APPENDIX C.2

APPENDIX C.2.1
2017 GEOTECHNICAL INSPECTION NO. 1

RE: Submission of 2017 Geotechnical Inspection Report No. 1 (Aug. 2017)

ANNUAL GEOTECHNICAL INSPECTIONS

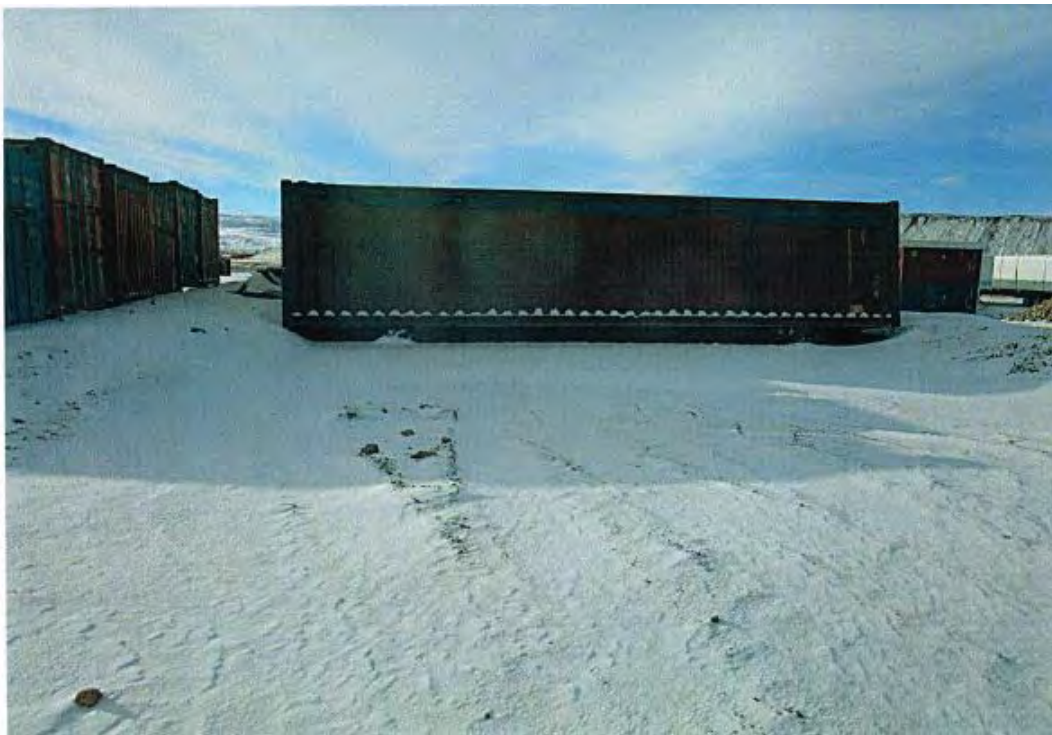
A new fueling facility for the fueling of B trains is in place with construction utilizing design drawings prepared by our office.

Work conforms to the design drawing.
